ADDENDUM NO. 2**Question and Answer Addendum****REQUEST FOR PROPOSALS FOR A SOLAR ENERGY POWER PURCHASE AGREEMENT TO PROVIDE SOLAR-GENERATED ELECTRICITY FOR MONROE TOWNSHIP SCHOOL DISTRICT FACILITIES**

This Addendum NO. 2 is issued on January 8, 2025, in order to provide answers and clarifications to the vendor's questions.

E3.1

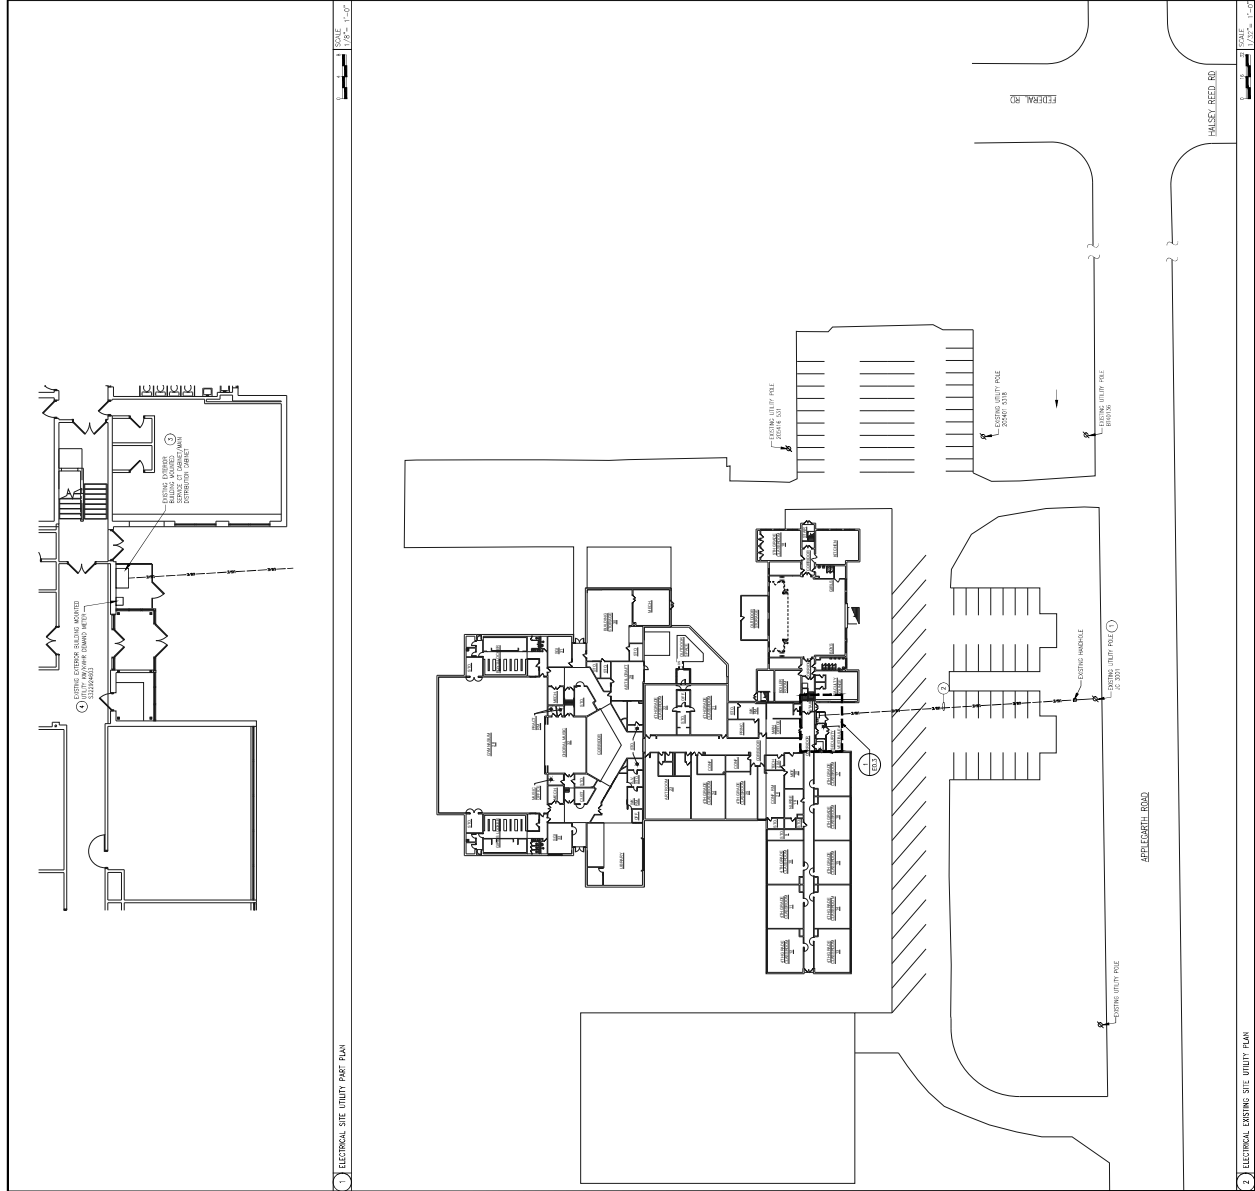
16. Question: Can you provide all electrical drawings for the proposed service upgrade work being done at Applegarth Elementary School?

Answer: Attached is the available information for the electrical upgrade at Applegarth Elementary.
